ADDENDUM

ADDENDUM NO: 03

PROJECT: Center Grove HS Renovations – Package 2

DATE: September 4, 2026

2 LOWER LEVEL - UNIT A
A201A SCALE: 1/8" = 1'-0"

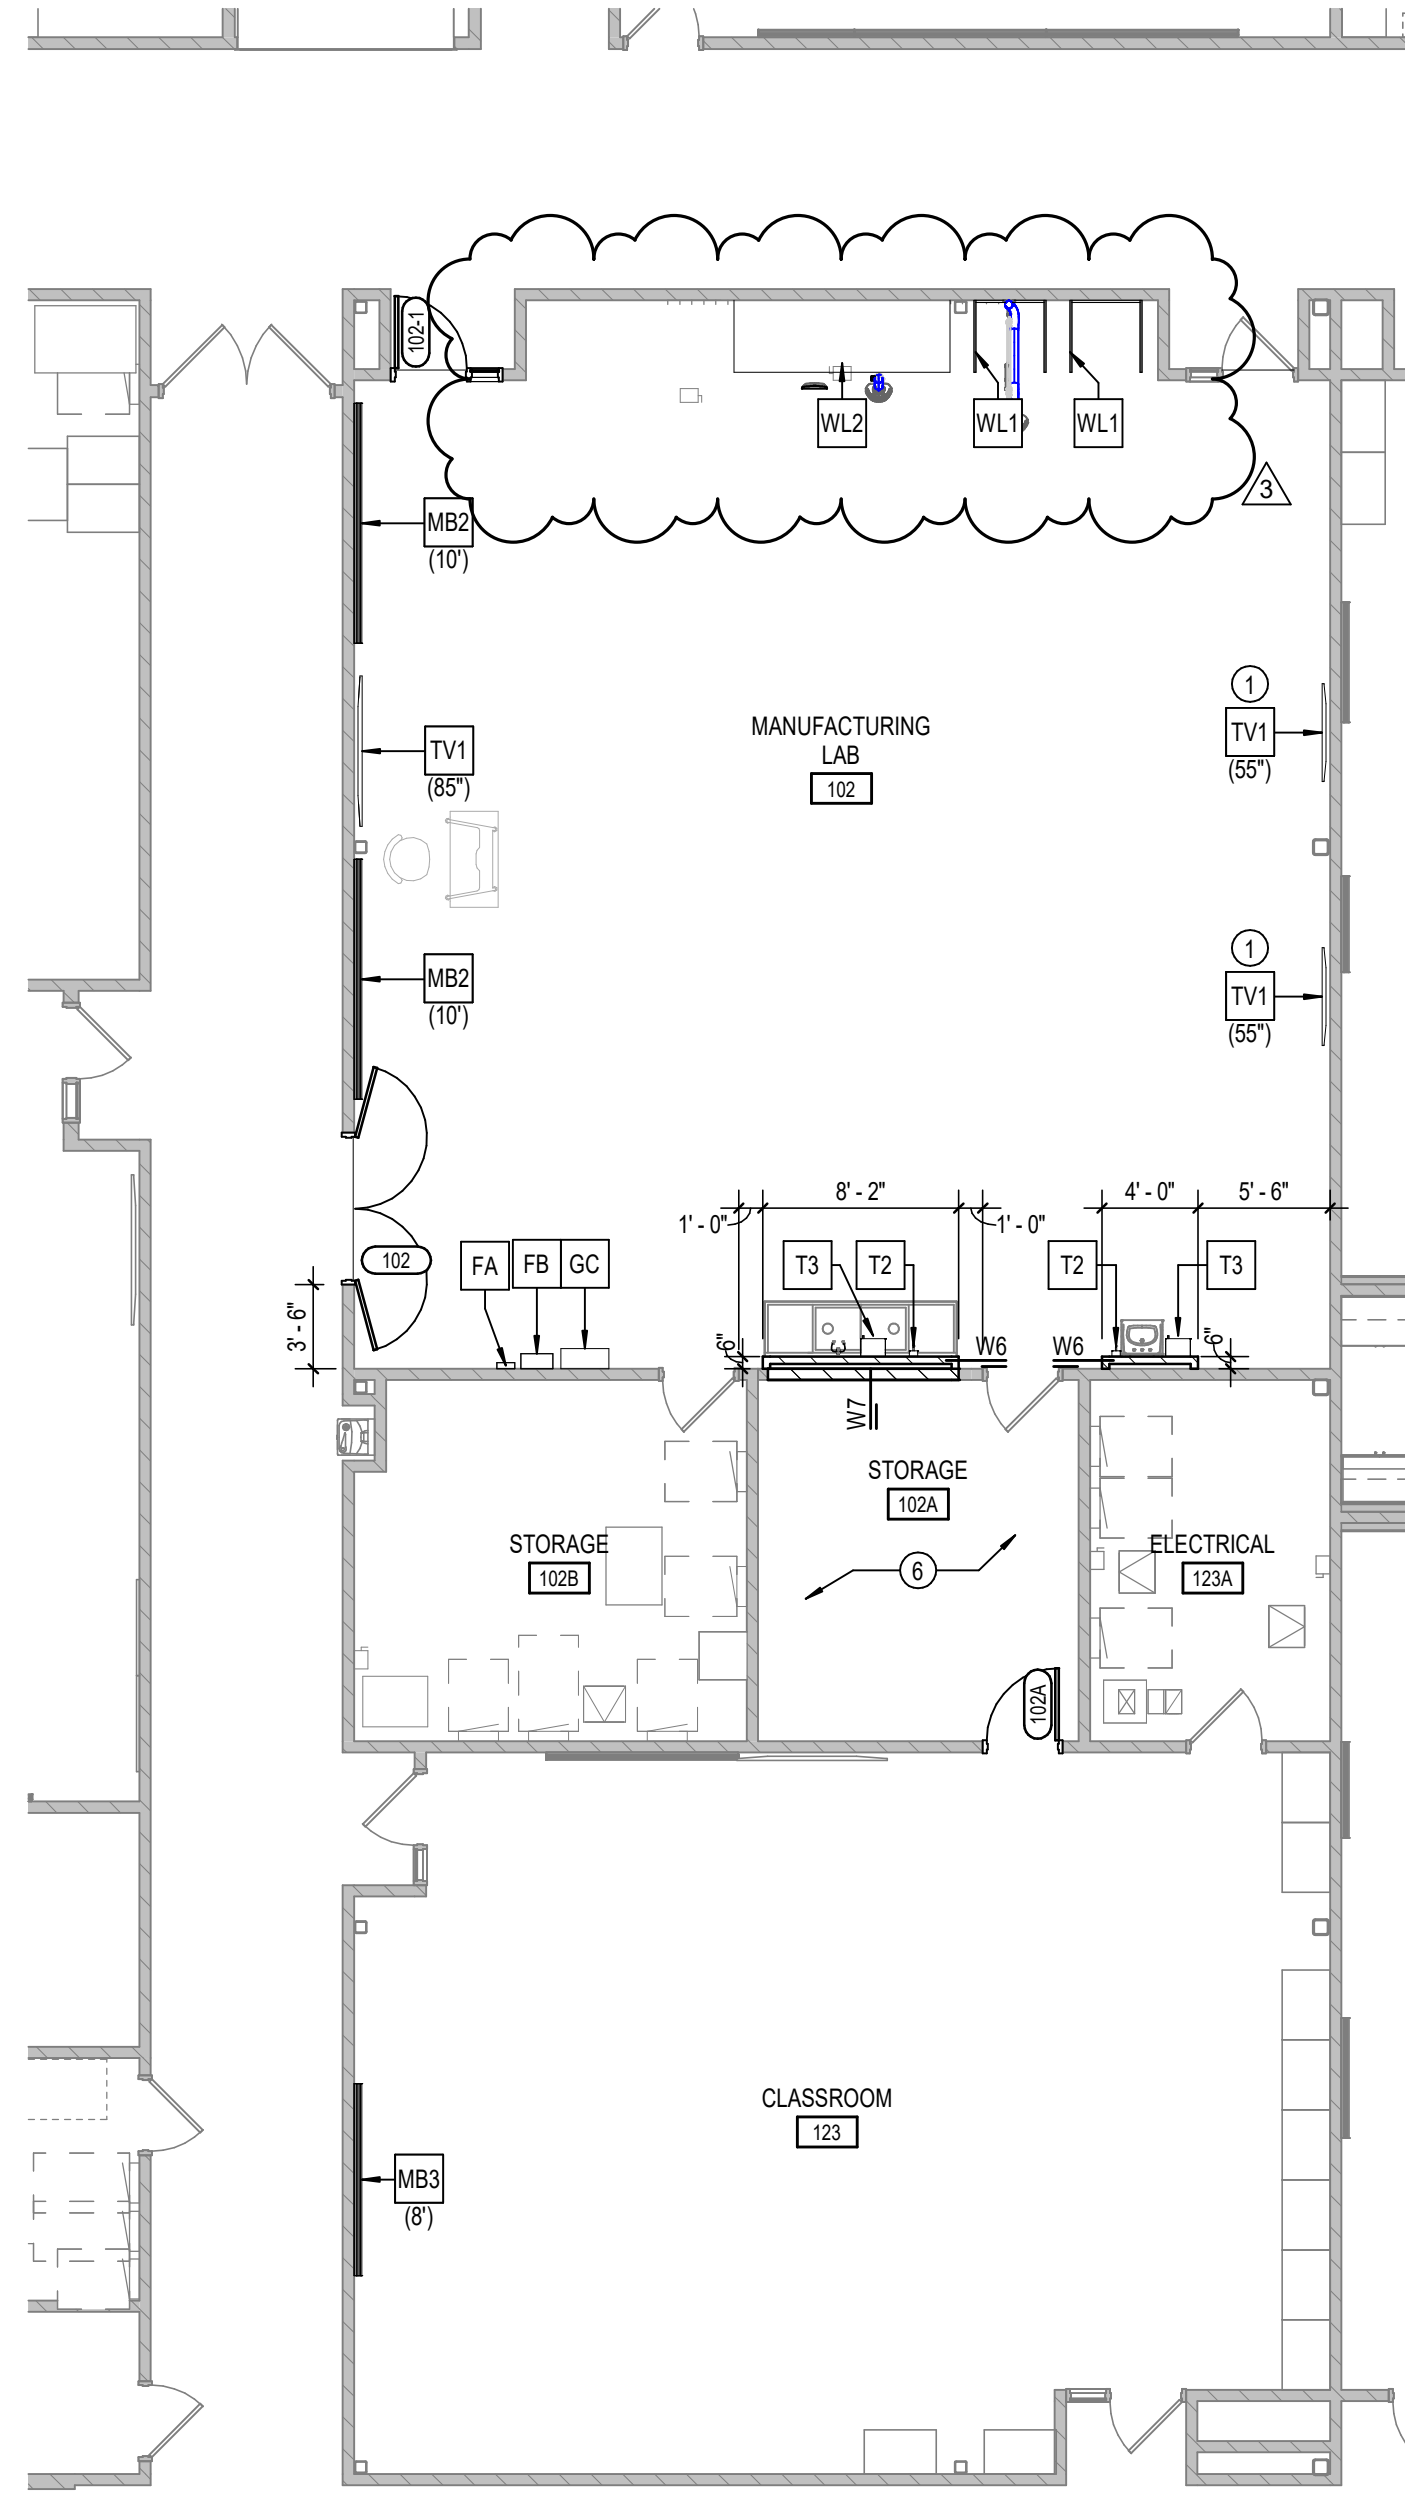
- A. Relocate WL1 Welding Booths as shown on attached sheet.

2 MECHANICAL PHASE 2 PLAN

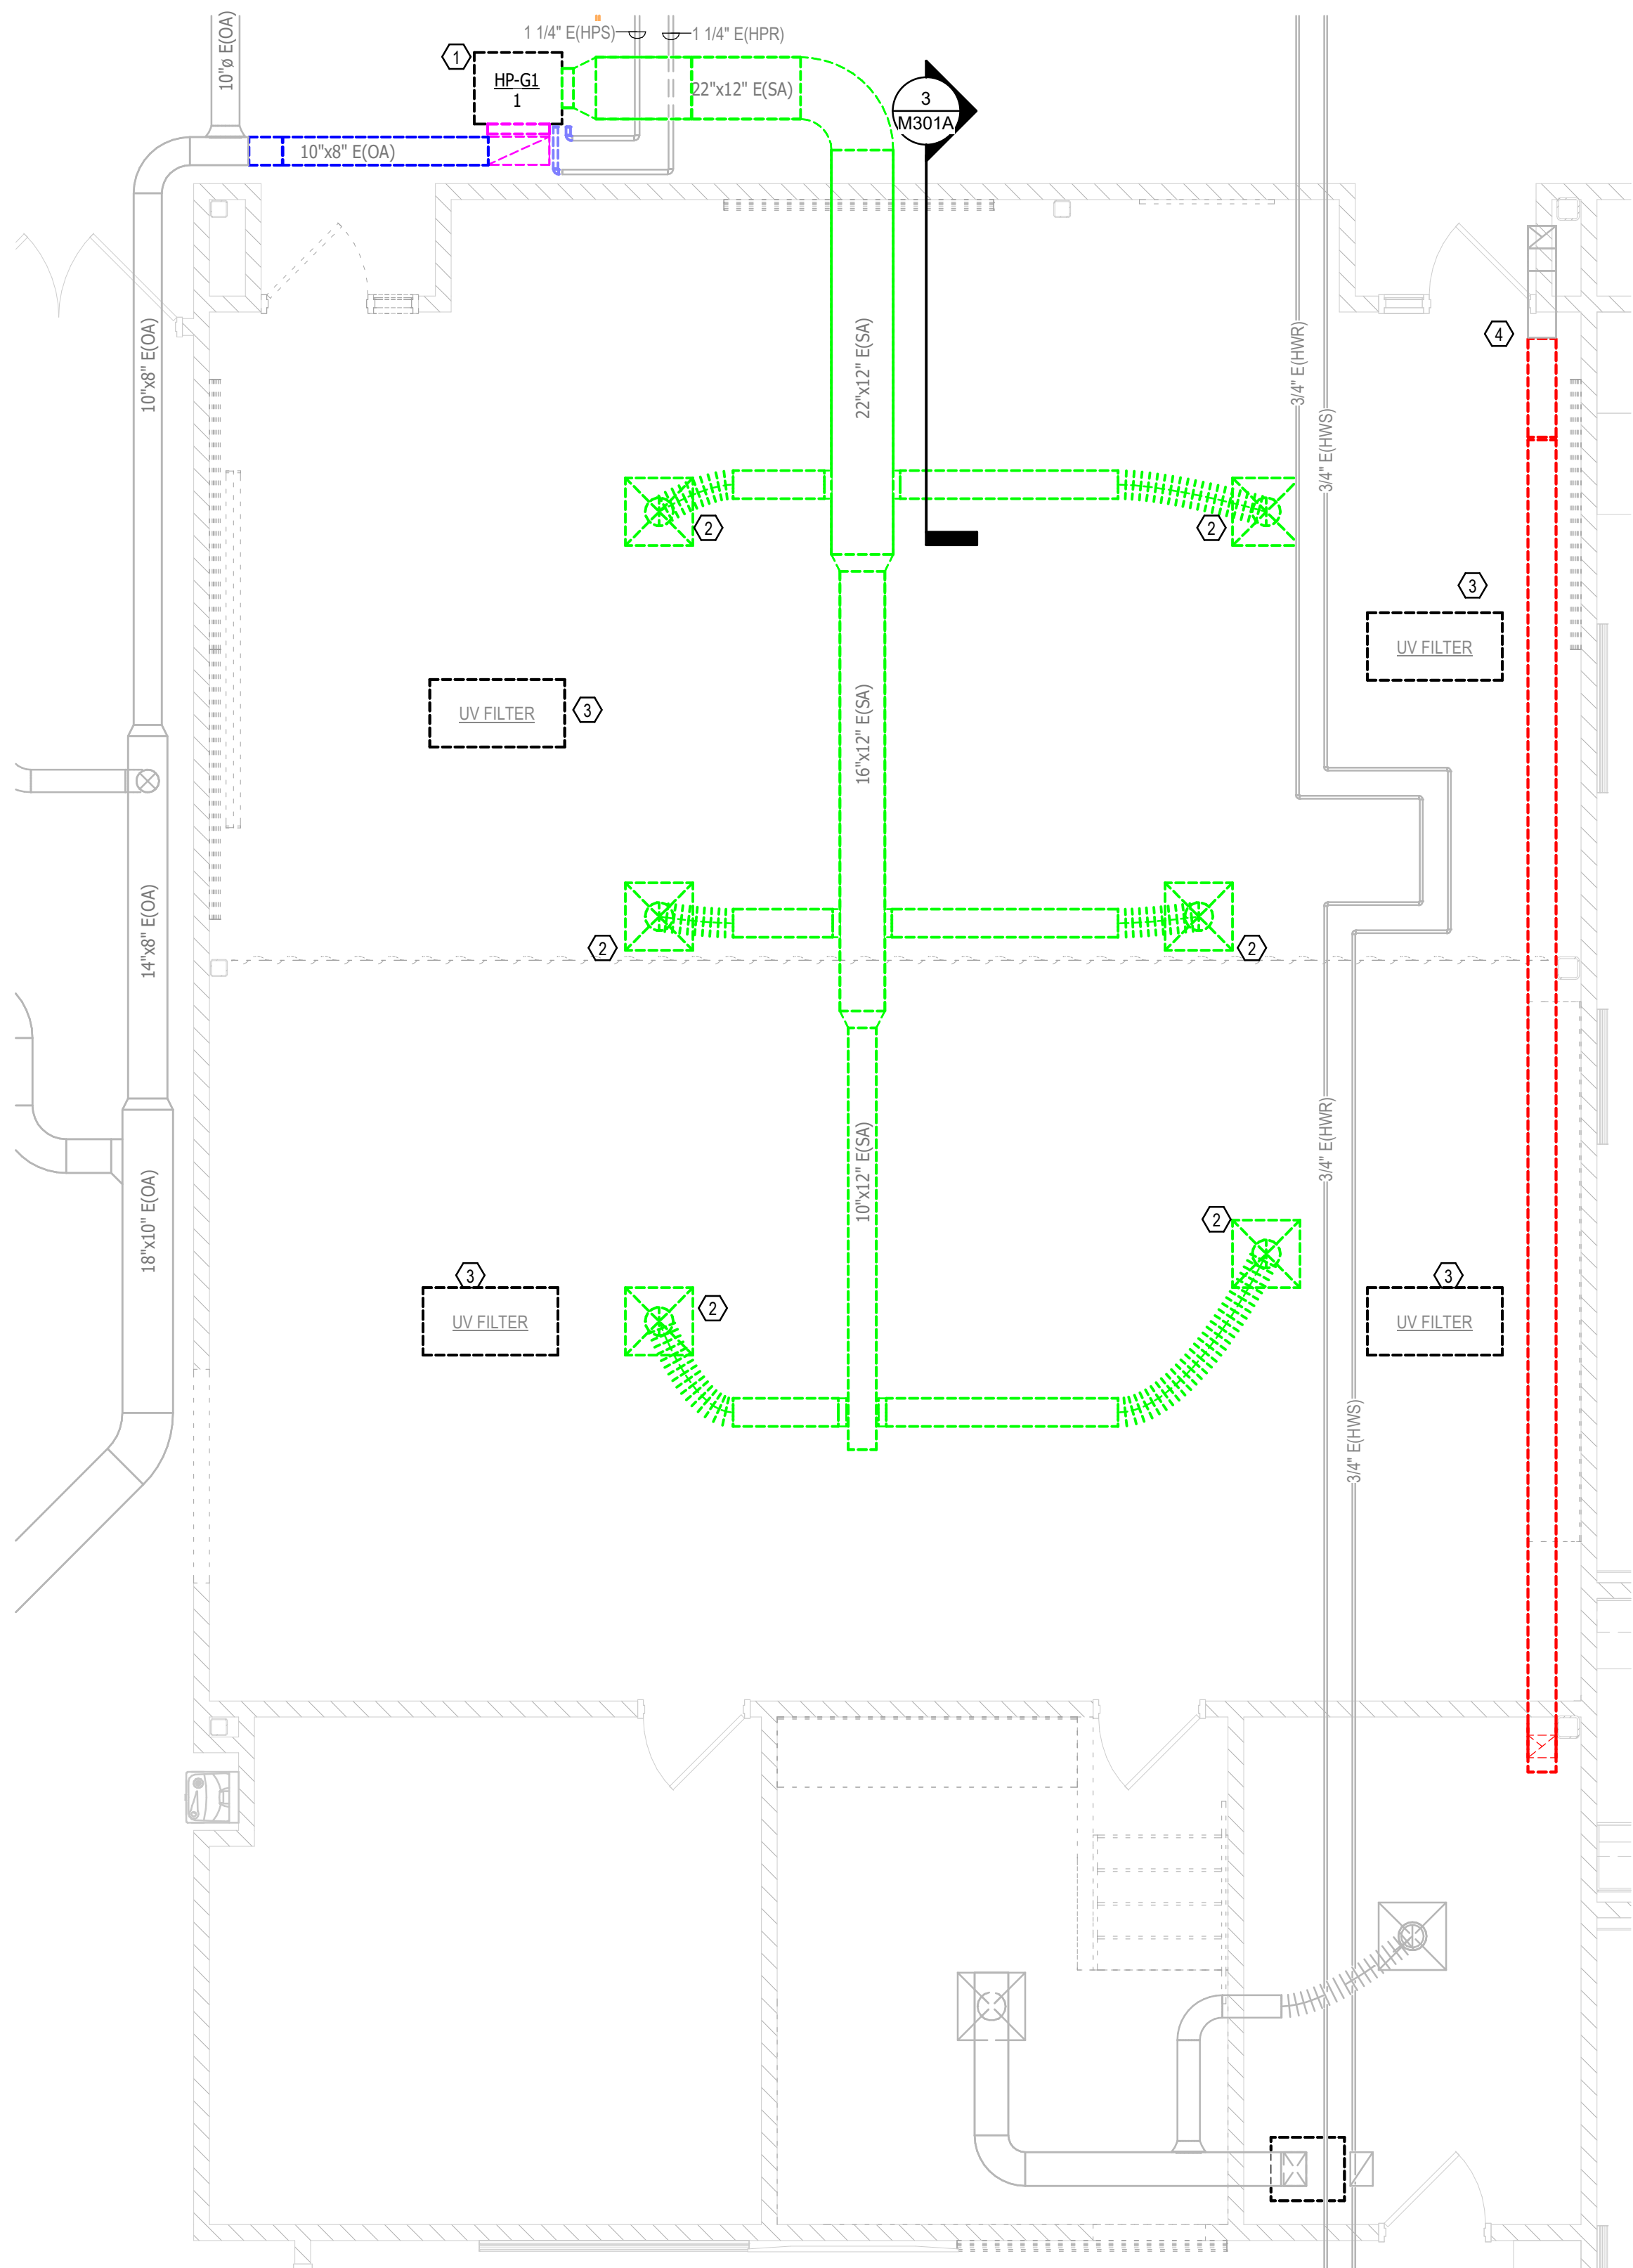
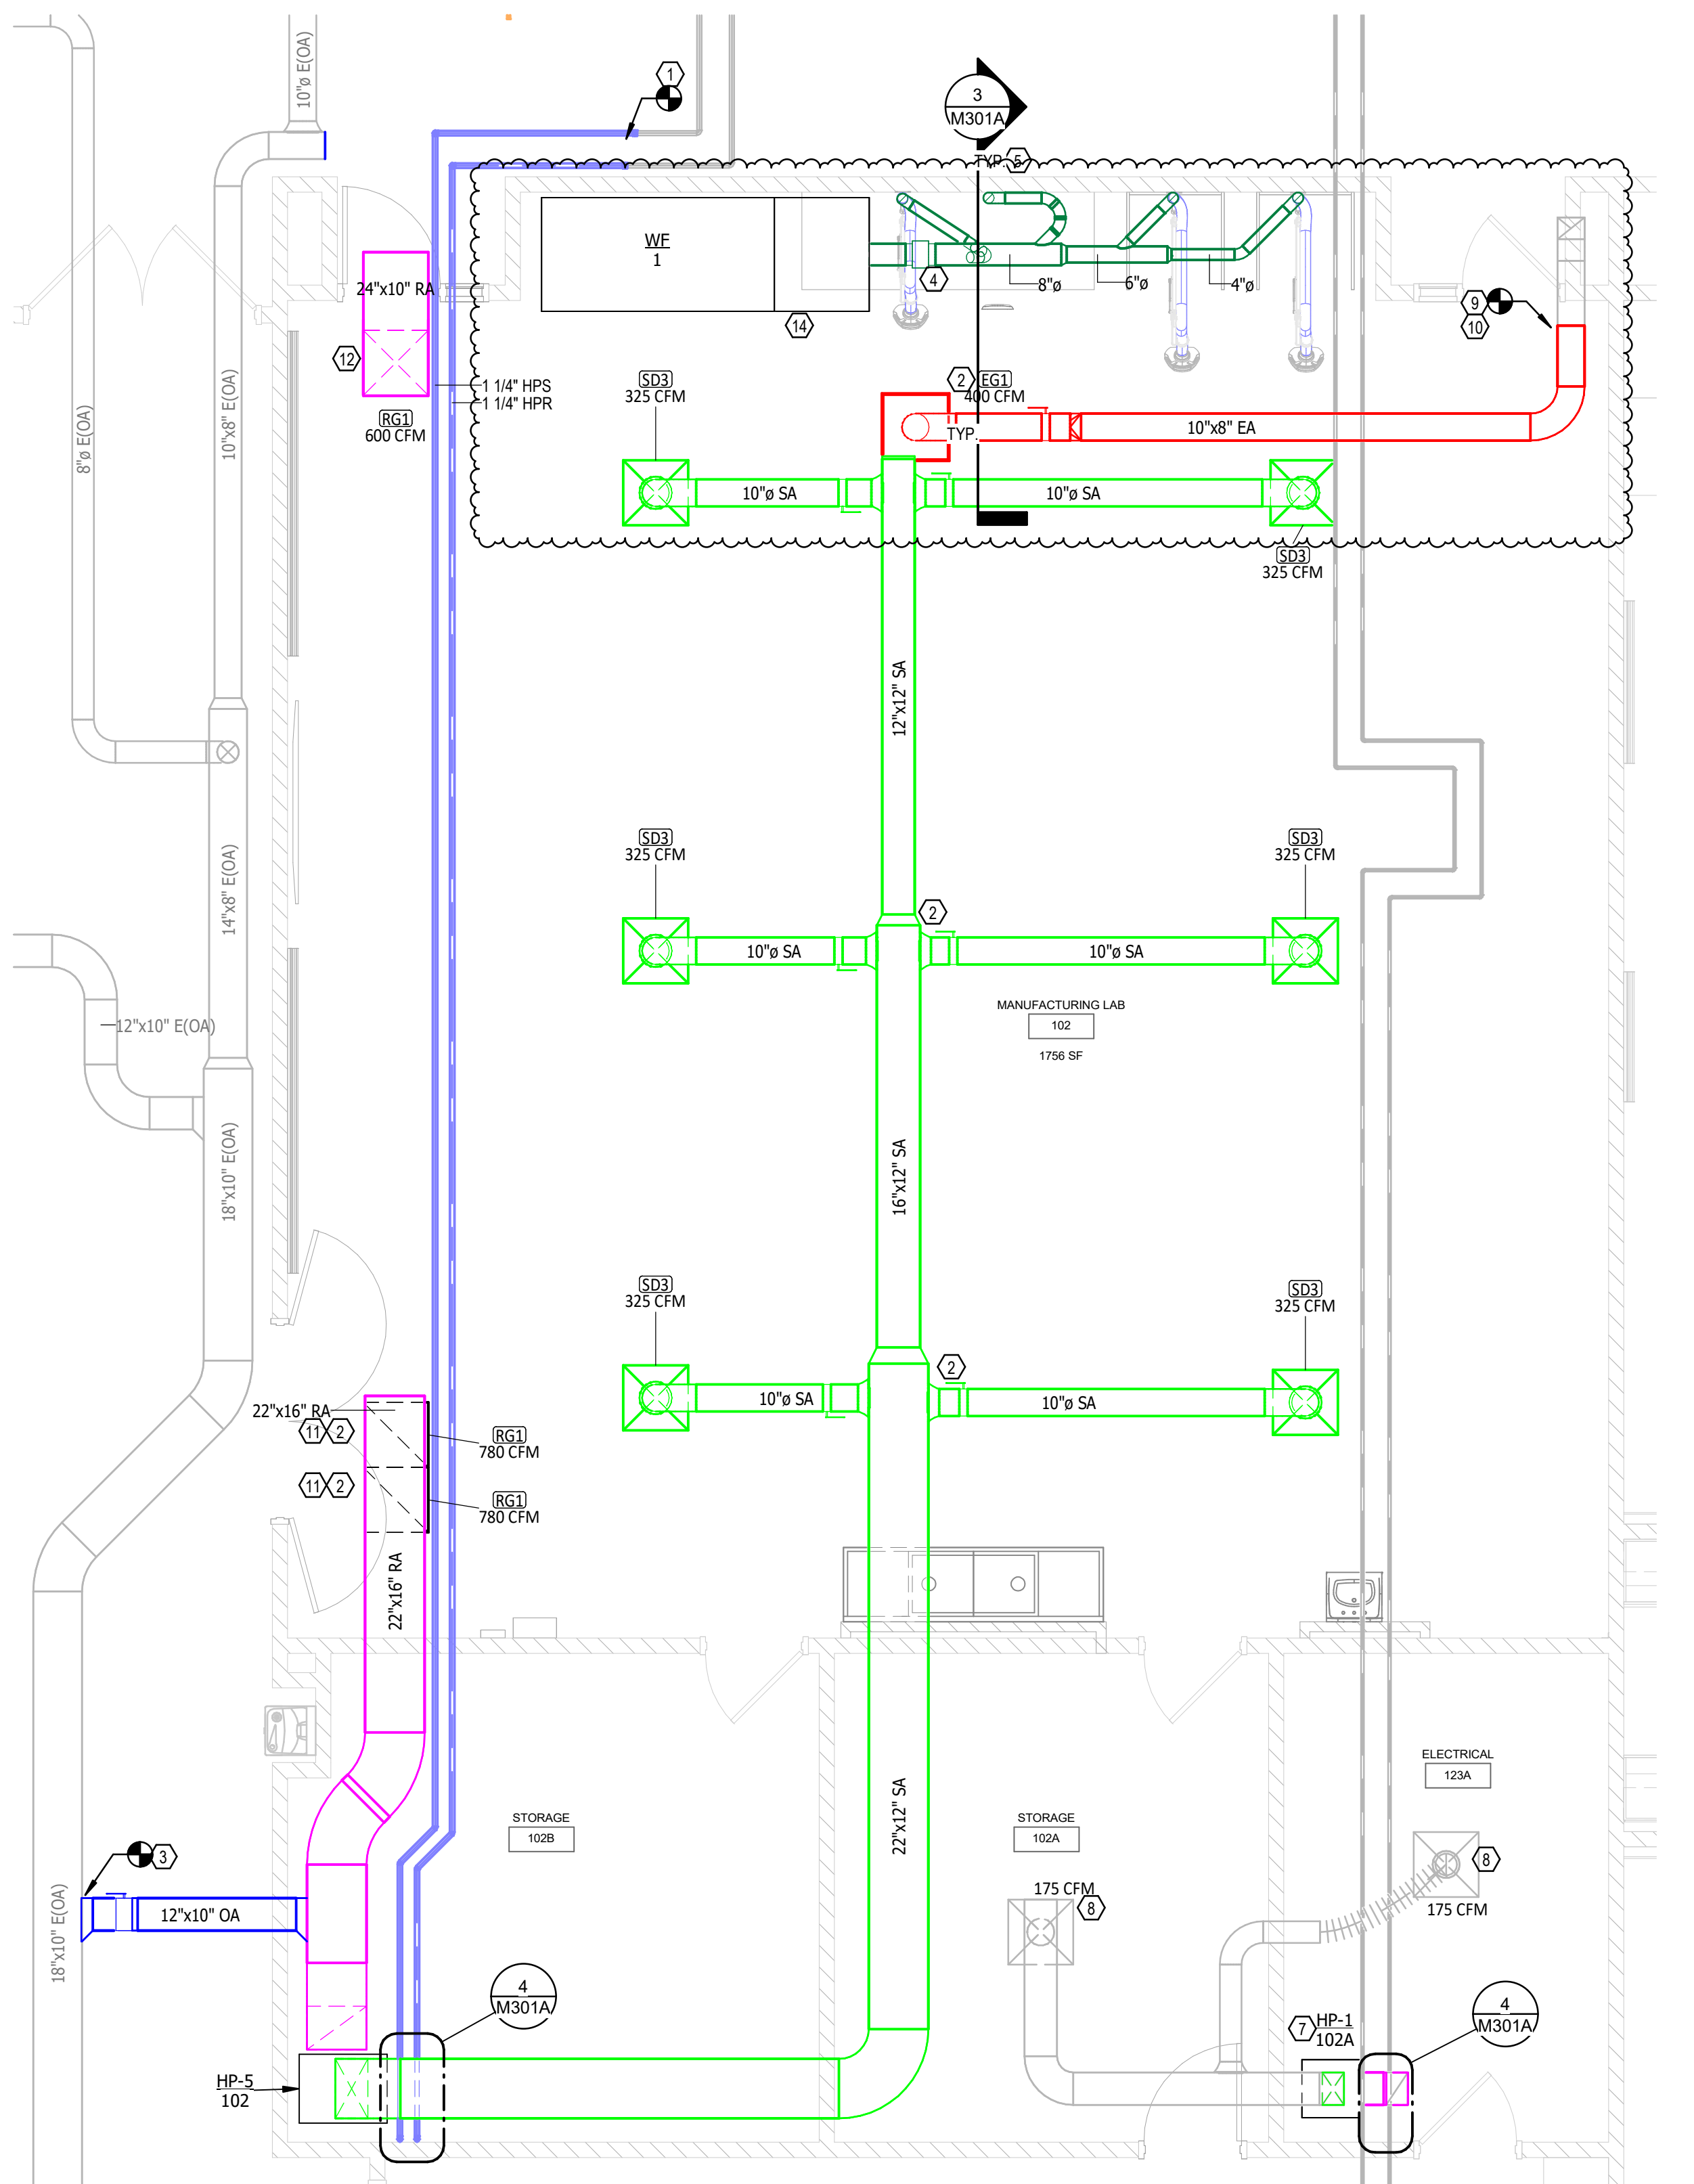
- A. Plans modified to provide carbon filtration with welding particulate filtration.
- B. Replacing two RP1 units with one MC3000 unit by microair.
